DUANE ARNOLD ENERGY CENTER

AMENDMENT TO FACILITY OPERATING LICENSE

Amendment No. 39  
License No. DPR-49

ATTACHMENT TO LICENSE AMENDMENT NO. 39  
TO THE TECHNICAL SPECIFICATIONS  
FACILITY OPERATING LICENSE NO. DPR-49  
DOCKET NO. 50-331

TABLE 3.12-1

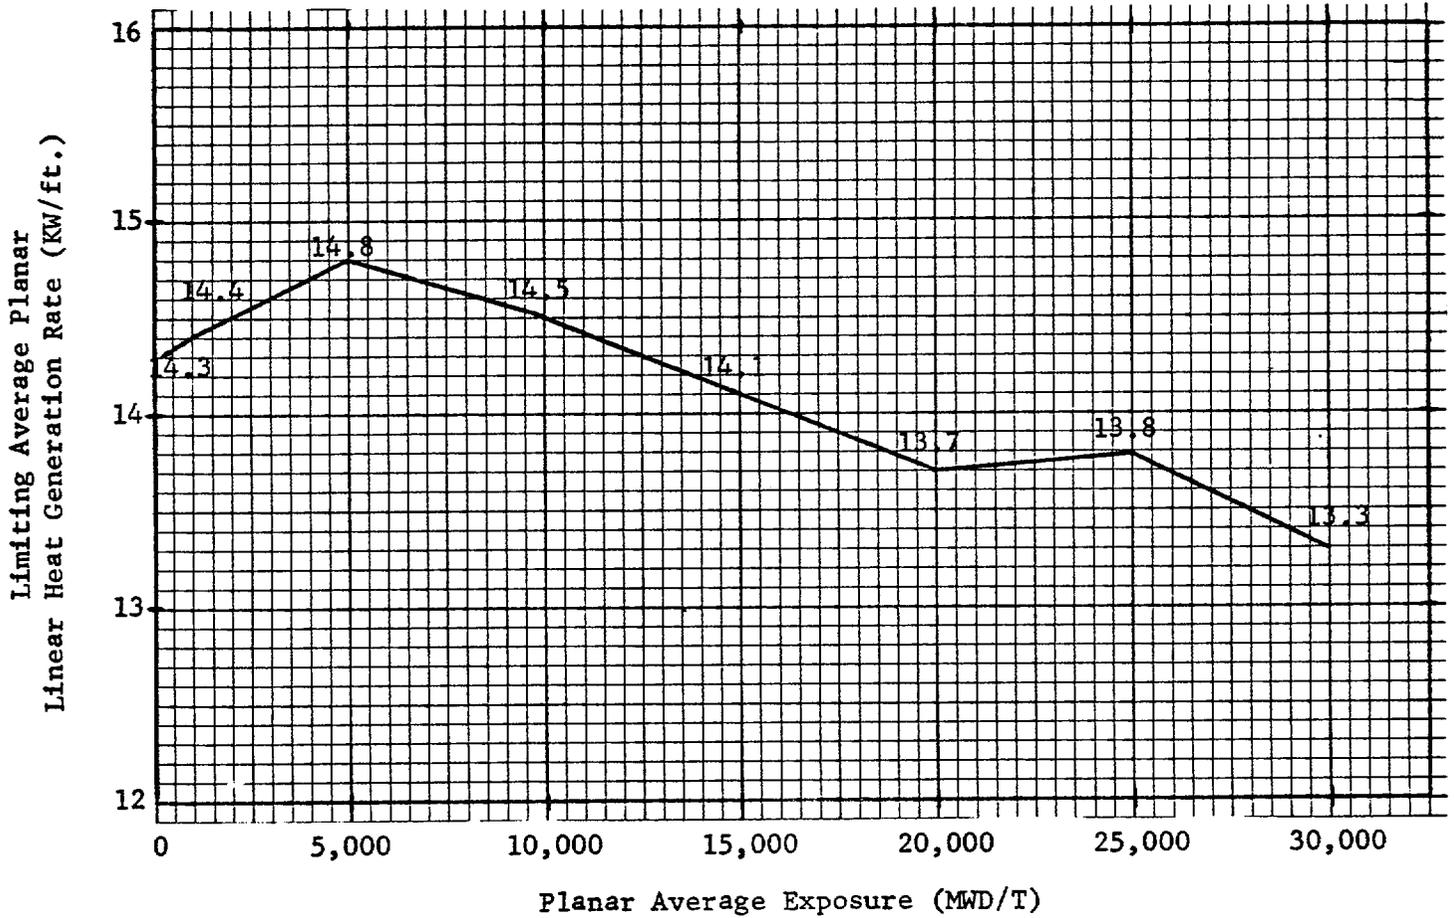
Core Thermal Power	$\frac{1655 \text{ MWt}}{105\%}$ which corresponds to vessel rated steam output	
Vessel Steam Output	$7.16 \times 10^6$ Lbm/h which corresponds to 105% of vessel rated steam output	
Vessel Steam Dome Pressure	1055 psia	
Recirculation Line Break Area for Large Breaks (ft <sup>2</sup> )	2.51 (DBA)	
Recirculation Line Break Area for Small Breaks (ft <sup>2</sup> )	1.0	0.05 (WSB)

FIGURE 3.12-2

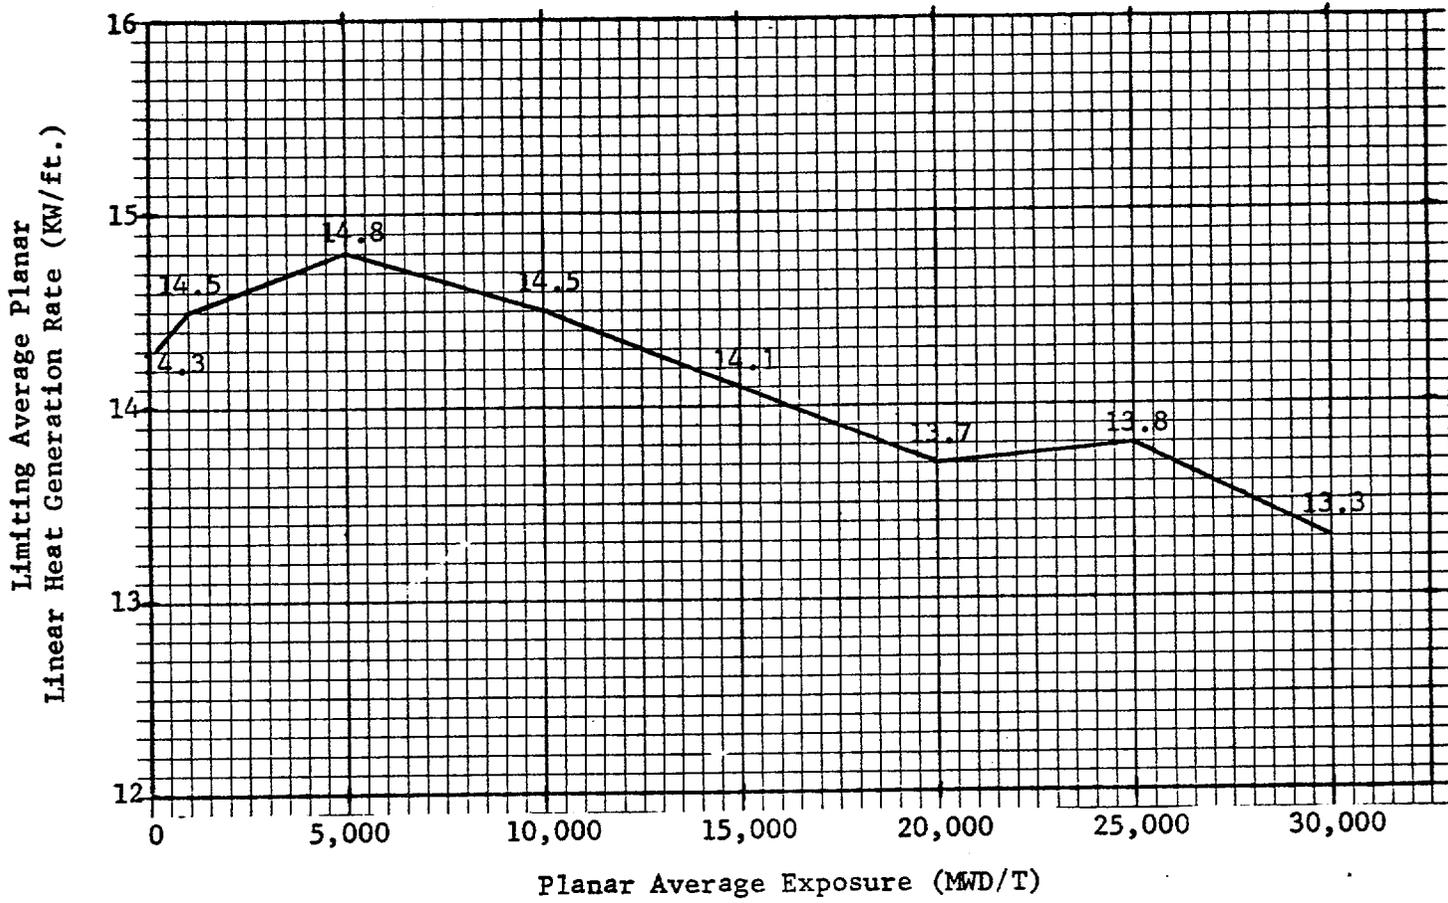
During reactor power operation, the actual MAPLHGR for each type of fuel as a function of average planar exposure shall not exceed the limiting value shown in Figs. 3.12-2, -3, -4, -5 and -6. If at any time during reactor power operation it is determined by normal surveillance that the limiting value for MAPLHGR (LAPLHGR) is being exceeded, action shall then be initiated within 15 minutes to restore operation to within the prescribed limits. If the MAPLHGR (LAPLHGR) is not returned to within the prescribed limits within two hours, the reactor shall be brought to the cold shutdown condition within 36 hours. Surveillance and corresponding action shall continue until the prescribed limits are again being met.

The peak cladding temperature following a postulated loss-of-coolant accident is primarily a function of the average heat generation rate of all the rods of a fuel assembly at any axial location and is only dependent secondarily on the rod to rod power distribution within an assembly. Since expected local variations in power distribution within a fuel assembly affect the calculated peak clad temperature by less than  $\pm 20^{\circ}\text{F}$  relative to the peak temperature for a typical fuel design, the limit on the average linear heat generation rate is sufficient to assure that calculated temperatures are within the 10 CFR Part 50, Appendix K limit. The limiting values for MAPLHGR's are shown in Figures 3.12-2, 3.12-3, 3.12-4, 3.12-5 and 3.12-6.
